**STAFF RECOMMENDATION**

**2806 Oakland Avenue**

**September 16, 2020**

**Application:** New Construction—Addition; Detached Accessory Dwelling Unit

Figure 2 (left) is the left façade and Figure 3 (right) is the right façade.

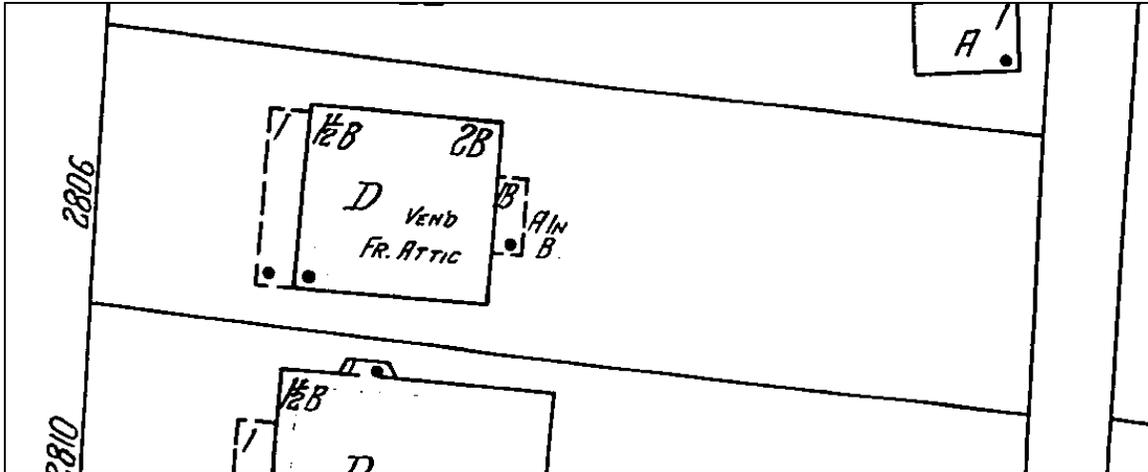
**Background:** 2806 Oakland Avenue is a c. 1930 Brick bungalow that contributes to the historic character of the Belmont-Hillsboro Neighborhood Conservation Zoning Overlay (Figure 1). While the house has a one-and-a-half story form on the front and right facades, on the left, the addition is two stories above a raised basement (Figures 2, 3). The 1931 Sanborn map show that this condition is historic (Figure 4).

**ARCHITECTURAL SITE PLAN**

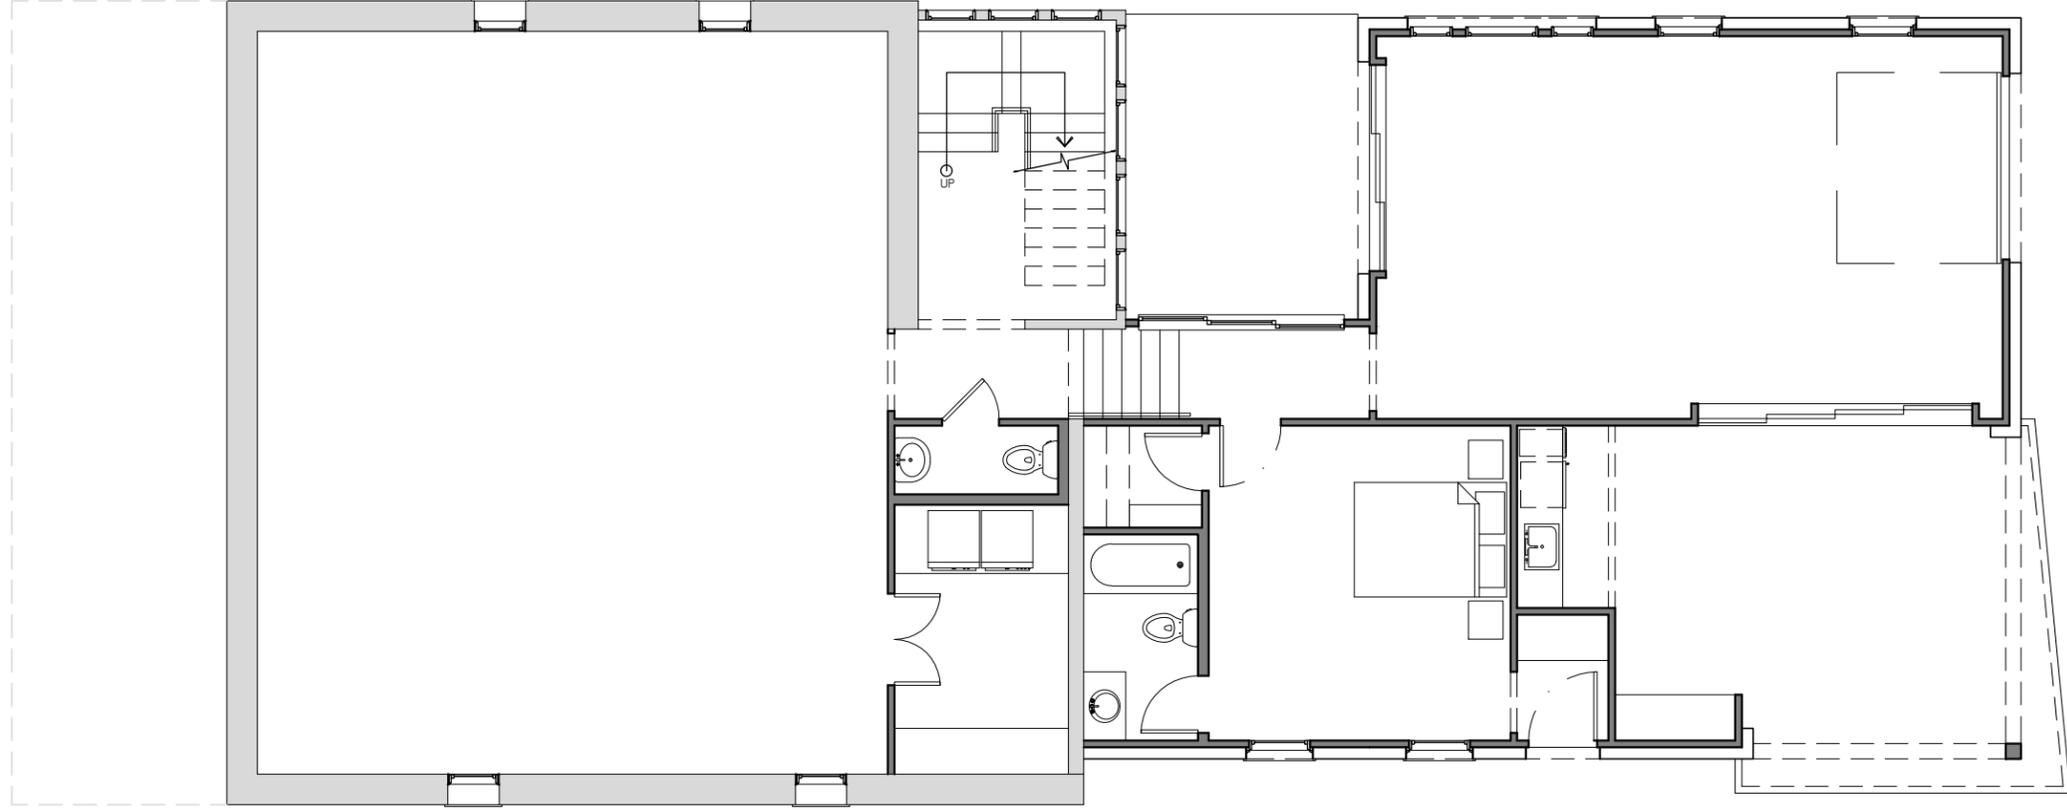
Setback & Rhythm of Spacing: The proposed addition meets all base zoning setbacks. It is five feet (5’) from the left side property line and about ten feet (10’) from the right side property line. It will be at least twenty feet (20’) from the proposed DADU and at least forty-five feet (45’) from the rear property line.

Staff finds that the proposed setbacks meet Section II.B.1.c. and II.B.2. of the design guidelines.

EXTERIOR ELEVATIONS

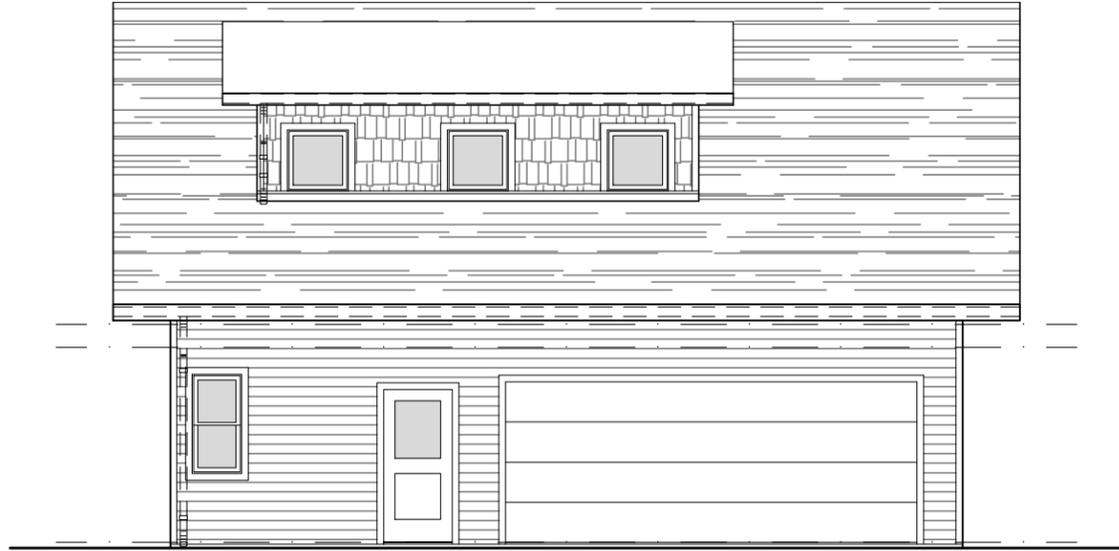
The rear portion of the left façade contains a rooftop deck. Staff finds that this deck increases the perceived height and scale of the addition and rooftop decks are not a historic roof form.

Roof form: The addition has a combination of gable roof forms to tie into the historic house’s gable forms. The gables have pitches of approximately 8/12. The left side has a gabled dormer that is inset two feet (2’) from the wall below. The right side has a shed dormer that is inset two feet (2’) from the wall below and four feet (4’) from the wall of the historic house. These roof forms are compatible with those of the historic house: however, the rooftop deck is not since such features did not exist historically. In addition, the rooftop deck increases the perceived height and scale of the addition.

With the condition that any rooftop deck be removed, staff finds that the proposed addition meets Sections II.B.1.a., II.B.1.b., and II.B.2. of the design guidelines.

With the condition that the rooftop deck be removed, staff finds that the proposed roof forms meet Sections II.B.1.e. and II.B.2. of the design guidelines.
